Minutes

Present:	Andy Connell, Manchester City Council Pete Mills, Renaker James Sidlow, Renaker Henry Mulligan, Simpson Haugh Katy Hayhoe, TPM Landscape David Dominguez, Curtins
Apologies:	Laura Wareing, Manchester City Council Richard Thomas, Manchester City Council Carl Peers, Curtins
Project:	Crown Street Phase 3 and Plot D Great Jackson Street
Job No:	081453
Date:	20/02/2023
Distribution:	Those present

Appendix – Adoption Plans

Orig Title: AREAS TO BE OFFERED FOR ADOPTION

Size:	Date:	Drawn By:	Designed By:	Checked By:			
A1	13/02/23	DD	DD	CP			
Scale: 1:250							
Project No:	Originator:	Volume:	Level:	Type:	Role:	Category / Number:	Rev:
081453 - CUR - XX - 00 - D - TP - 06006 - P02

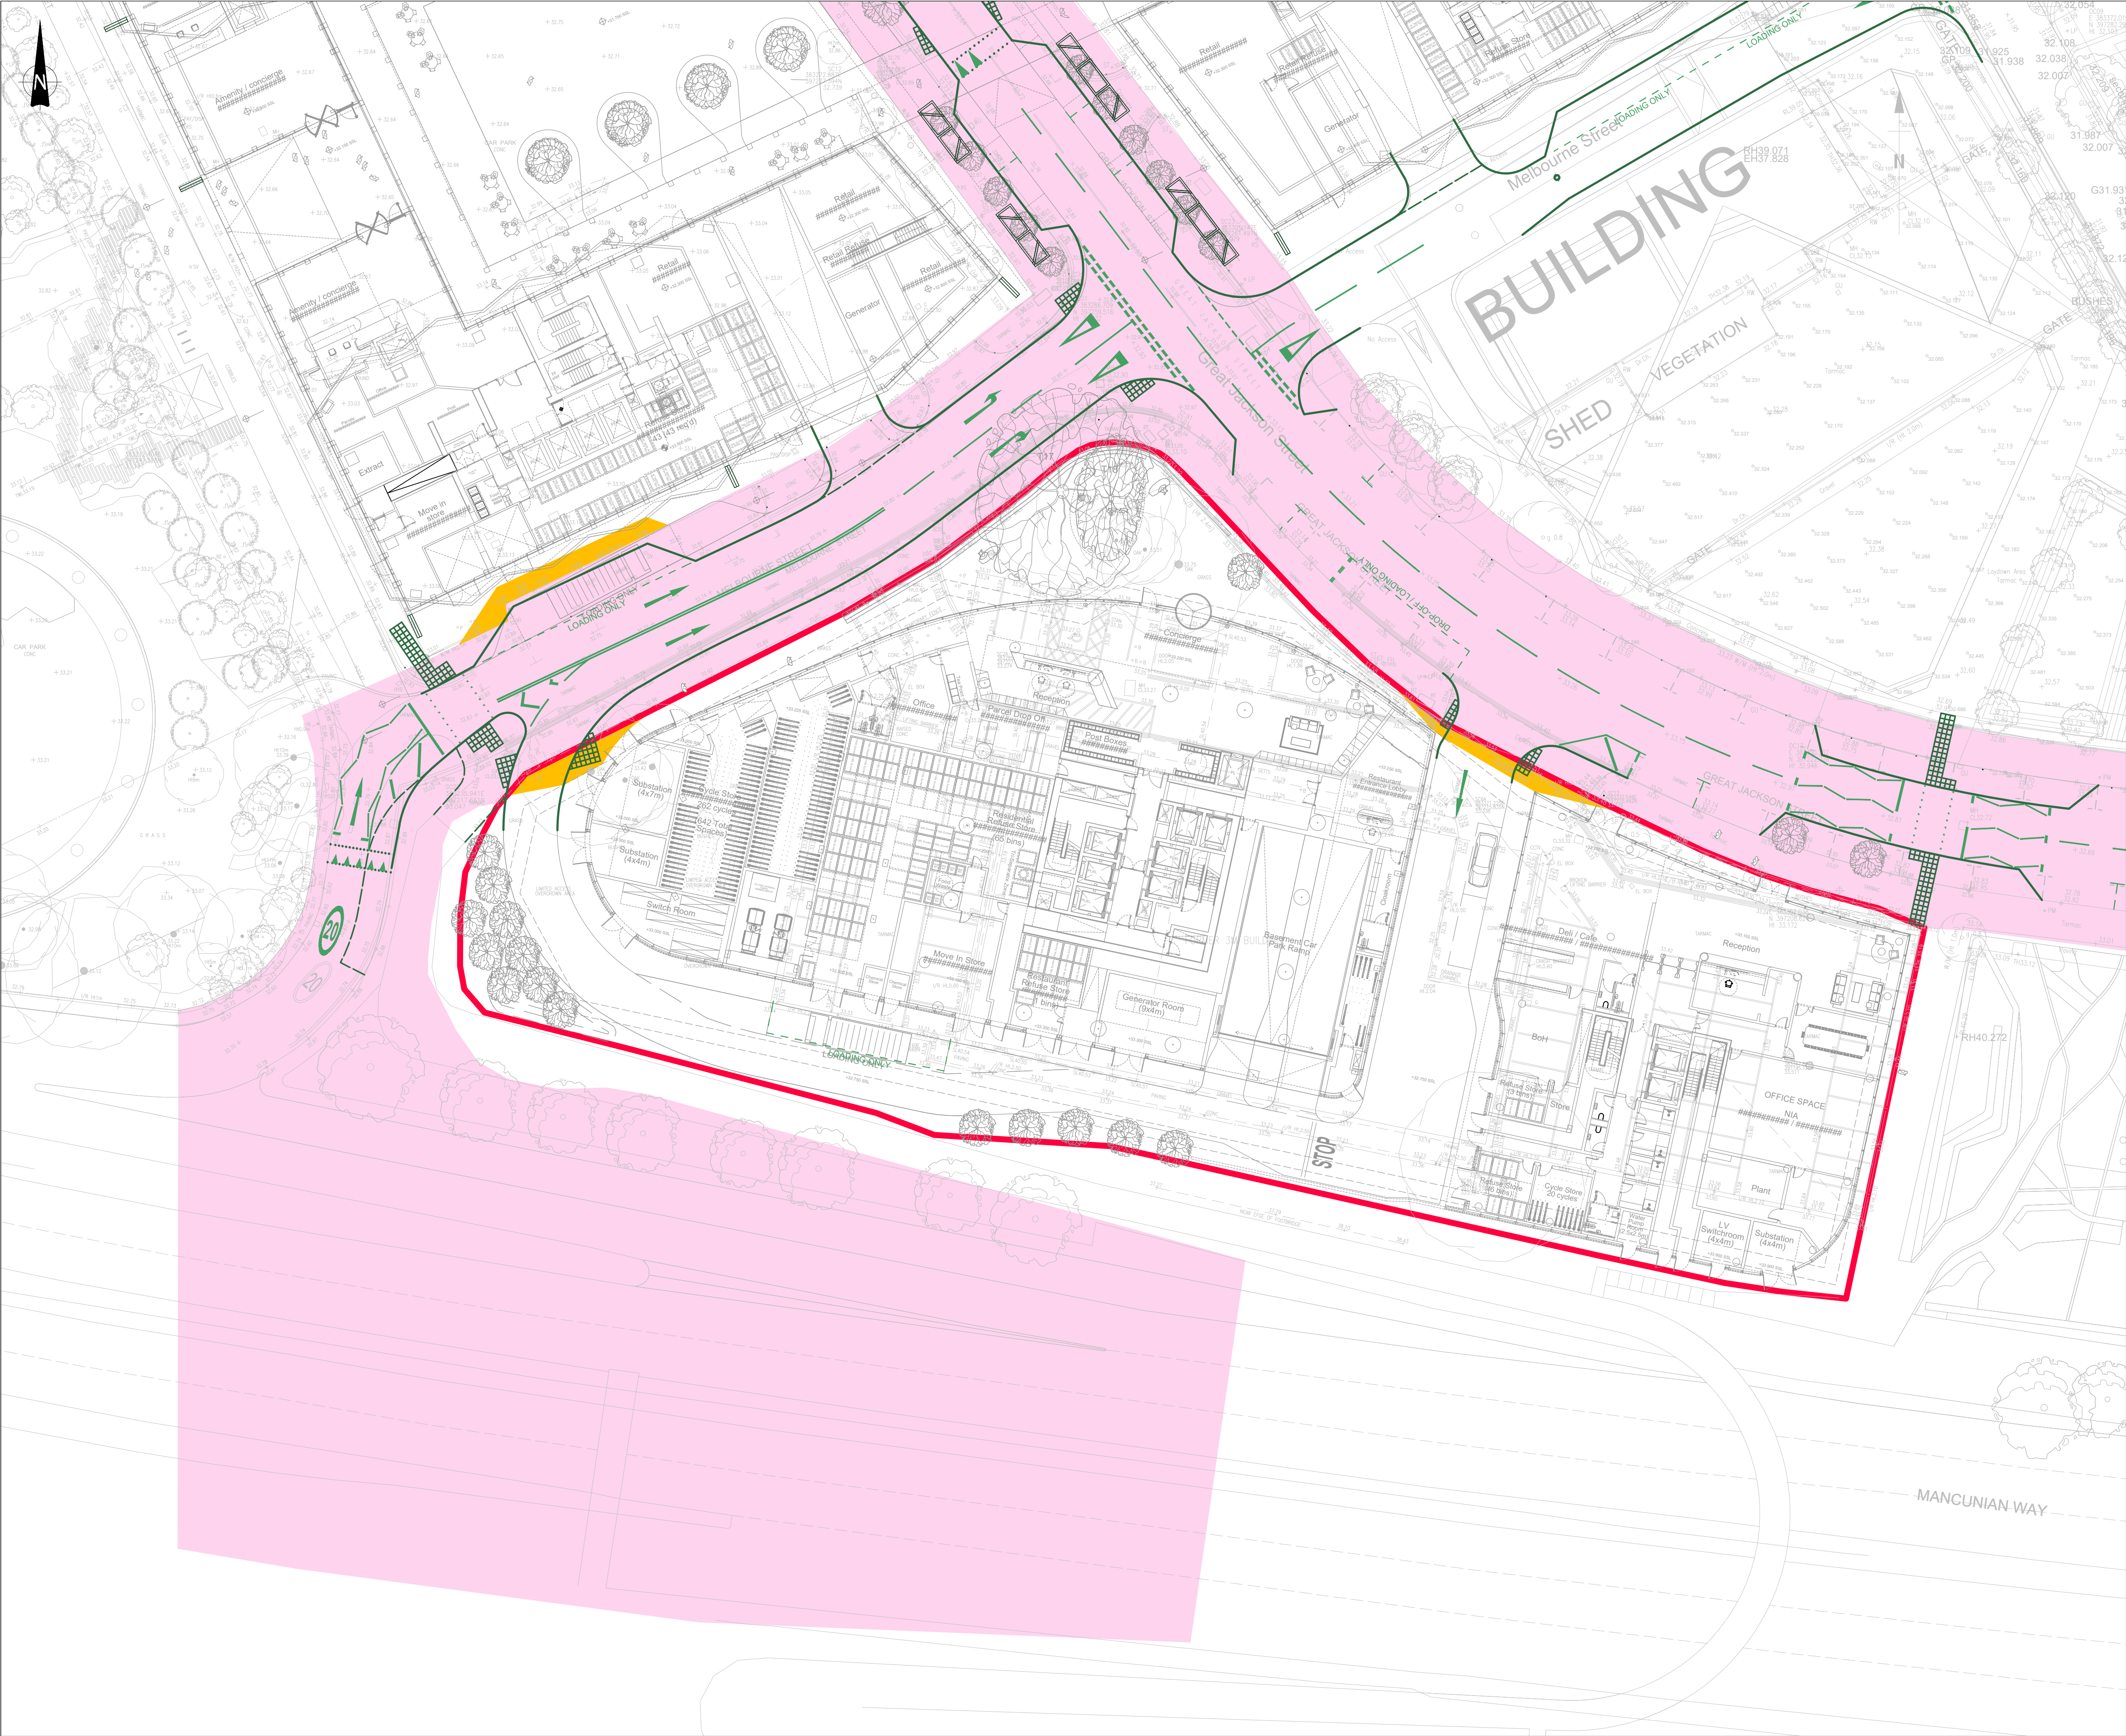
- 2.01 Curtins explained the land to be adopted as part of the Plot D planning application, sharing via Teams Drawing 081453-CUR-XX-00-D-TP-06006-P02 as reference (and attached to the rear of this note), and the rationale behind the proposed areas to be adopted (i.e. whole pedestrian crossings to be adopted, minimum 2m footway maintained, adoption to follow basement capping beam, etc.). MCC agreed with the approach and areas to be adopted. Curtins clarified that the office development is still being evolved, but that the principles of adoption should not change.

- 2.02 Curtins also explained the land to be adopted as part of Phase 3 to the south of Tower C7, along Melbourne Street and based on the same drawing. A 2m footway would be retained to the rear of the proposed loading bay. MCC was also in agreement with the proposed area to be adopted. Oversailing was discussed at this point, but this will be covered in detail on the following Chapter 3.

- 2.04 Curtins discussed the adoption areas along Silvercroft Street, following the same principle as along Melbourne Street (2m footway retained, albeit with the minor pinch point to the south of the loading bay). MCC agreed with the adoption areas in principle.
- 2.06 MCC requested confirmation of the agreement with Neil Bayliss-Rowe regarding the wind mitigation along Great Jackson Street.
